**Proposed Composite Development (with Flat and Retail/F&B)
with Minor Relaxation of Plot Ratio Restriction
in "Commercial (2)" Zone at 8 Lam Chak Street, Kowloon
- S16 Planning Application –
TPB Ref.: A/K22/50
Further Information No. 2**

(Planning Application No: A/K22/50)

RESPONSE-TO-COMMENT TABLE

Viewpoint 6 – Kwun Tong Promenade

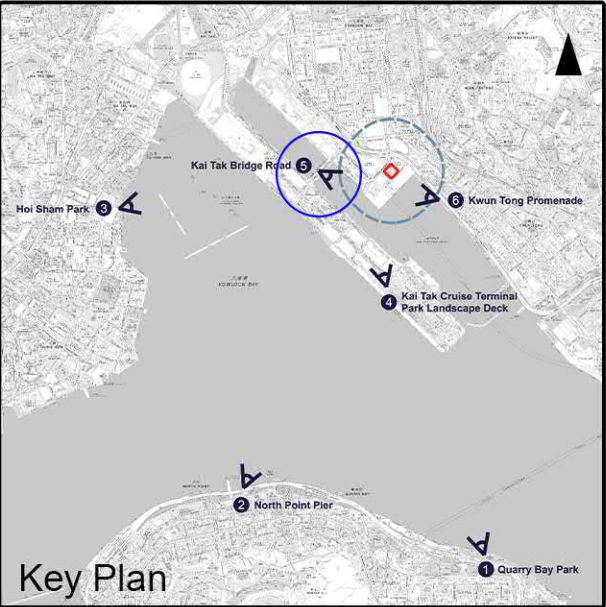
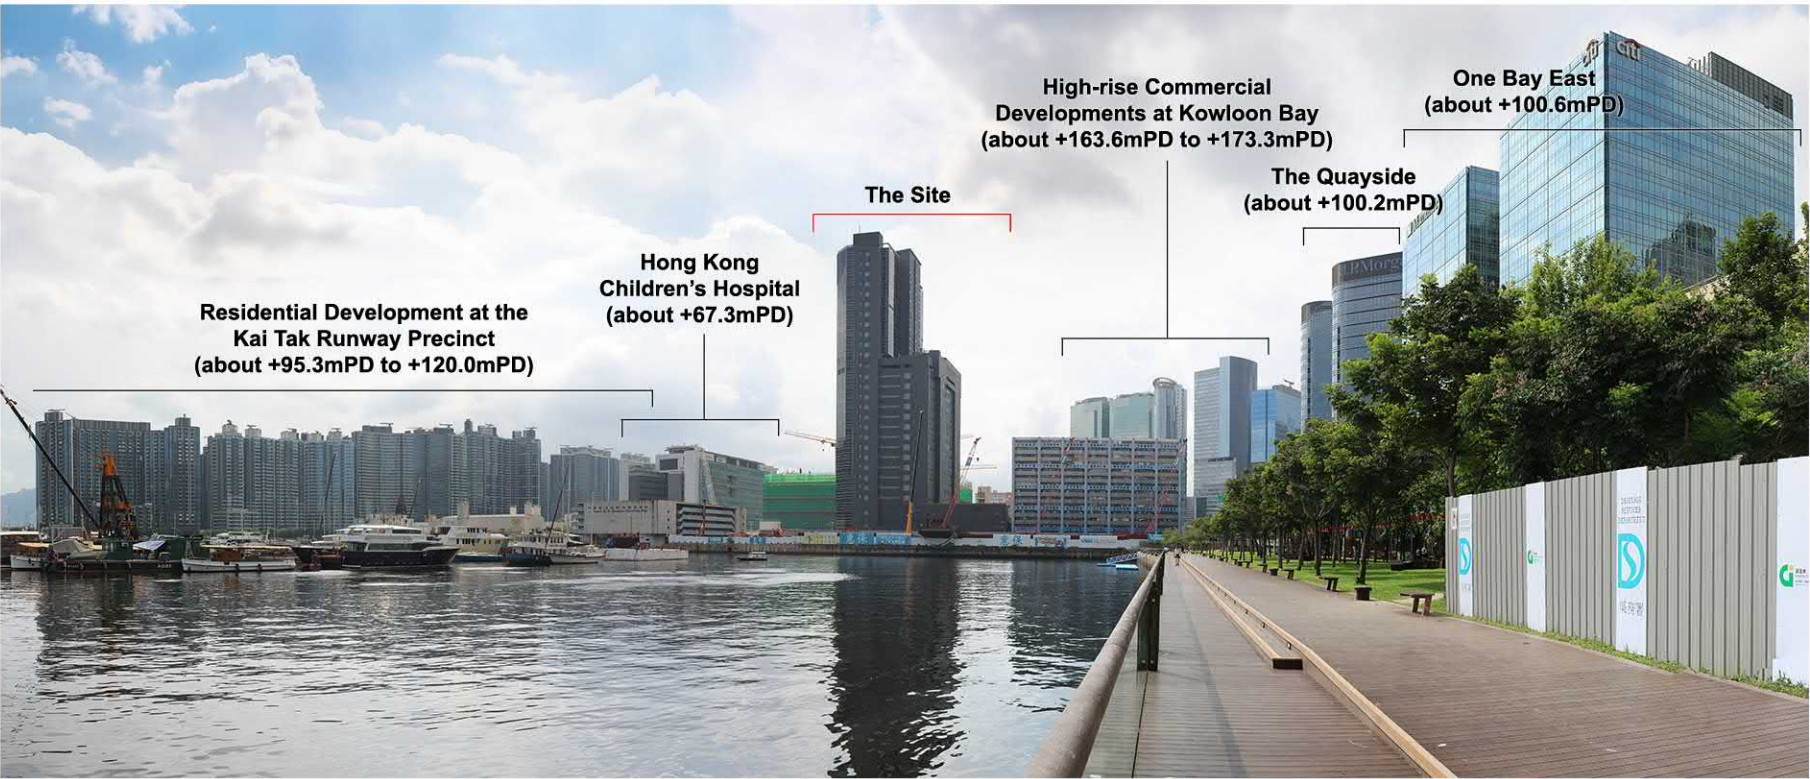
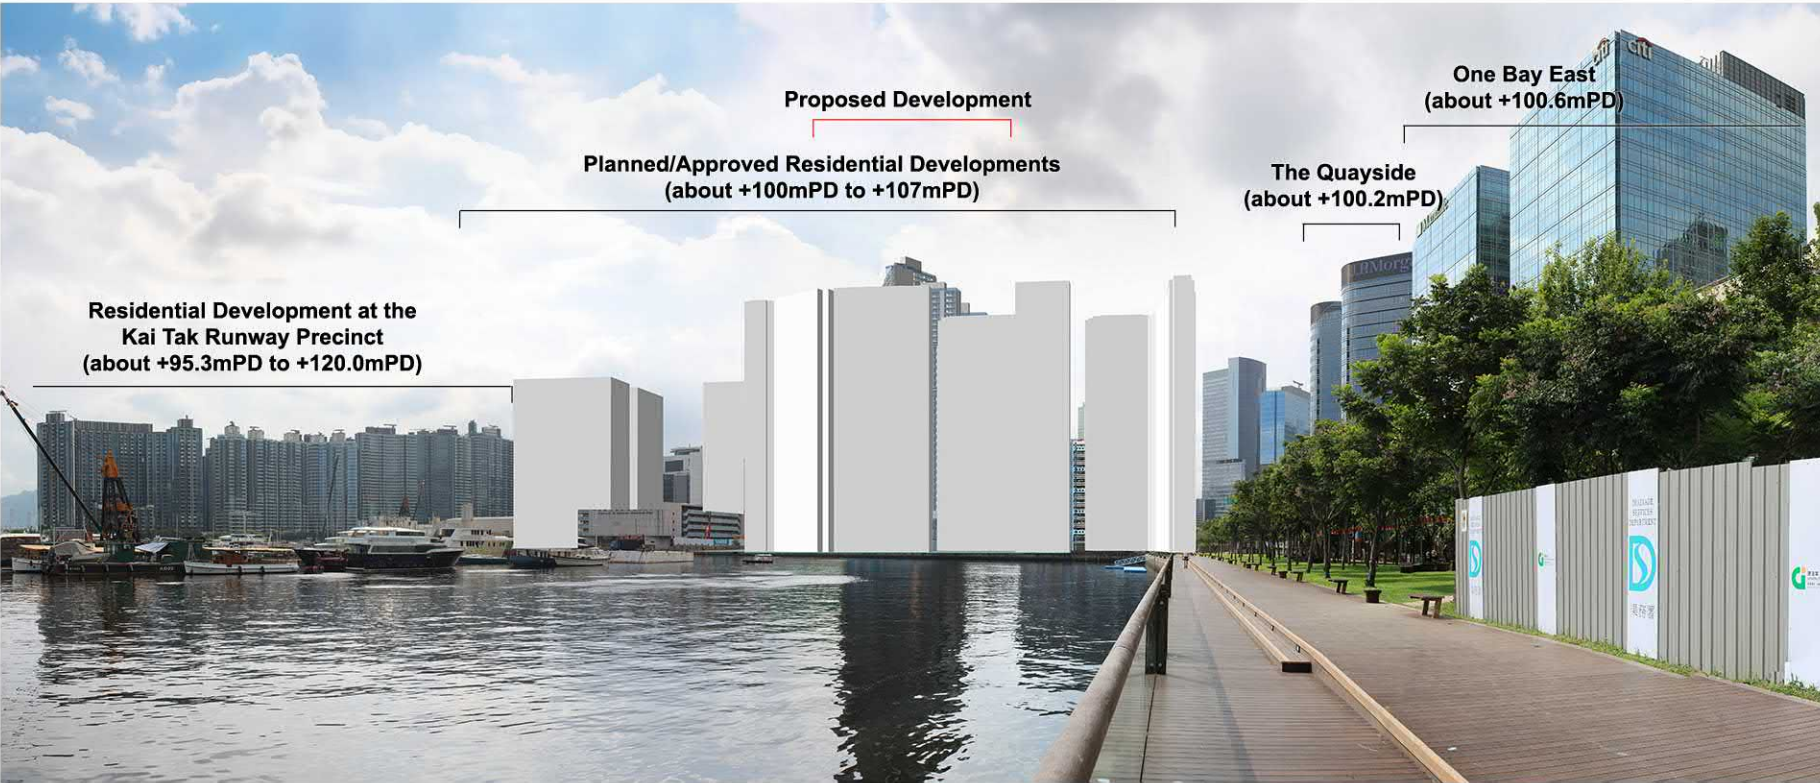
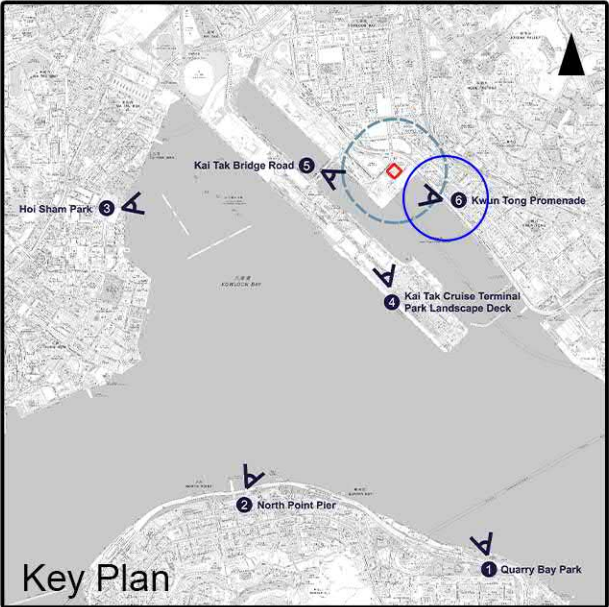
5. Table 7.1 – the overall ratings of visual impact for VP2 and VP6 are inconsistent with the analysis of visual change for the two VPs in Paras. 6.3.3 and 6.7.3.	Noted, relevant sections have been updated (<i>Appendix IV</i> refers).
